UNITED STATES PATENT AND TRADEMARK OFFICE

APPLICATION NO.	FILING DATE	FIRST NAMED INVENTOR	ATTORNEY DOCKET NO.	CONFIRMATION NO.
10/055,582	01/23/2002	Dennis P. Silver	11899	7015

Office Action Summary

DETAILED ACTION

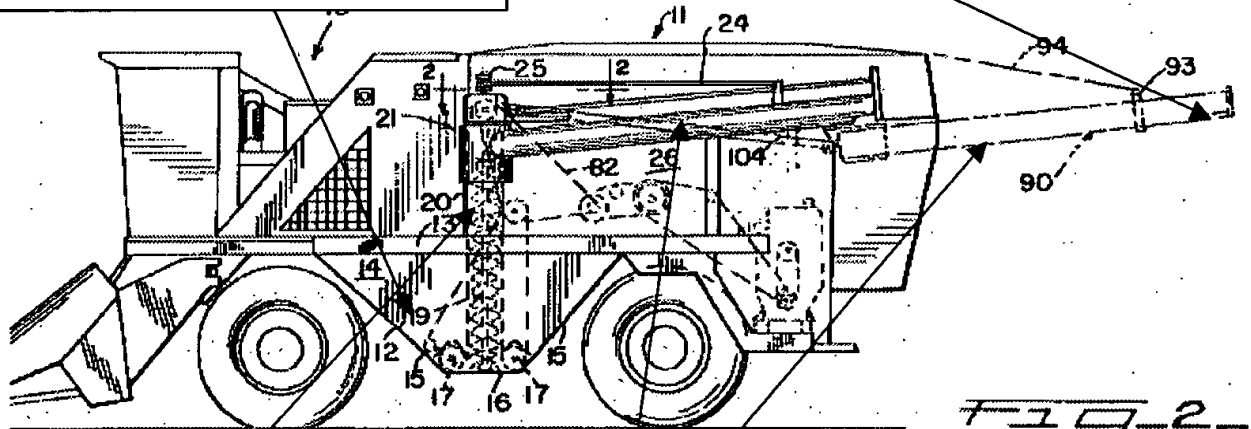
In re independent claims 1 & 6, Pool discloses the claimed invention as disclosed and outlined in the marked up drawings shown below, it is noted however that claim 6 does not have "substantially vertical infeed section coupled to the first segment";

Storage bin of a combine (cl. 6); wherein the storage bin defines an upper surface, and wherein the horizontal section is in communication with the upper surface (cl. 16)

Auger exit (cl. 15)

Substantially vertical infeed section coupled to the first segment (cl. 1)

Substantially horizontally positioned first and second segments of an unloading outfeed auger section, parallel to the combine's longitudinal axis in storage & unloading positions (cl. 1) and manually movable with respect to the storage bin (cl. 6 & 8)

Pool discloses the claimed device except for coupling the first & second segments in a side by side arrangement when in storage by using a hinged connection which can be moved into position by any well known means such as a hydraulic actuator connected between the two segments as claimed.
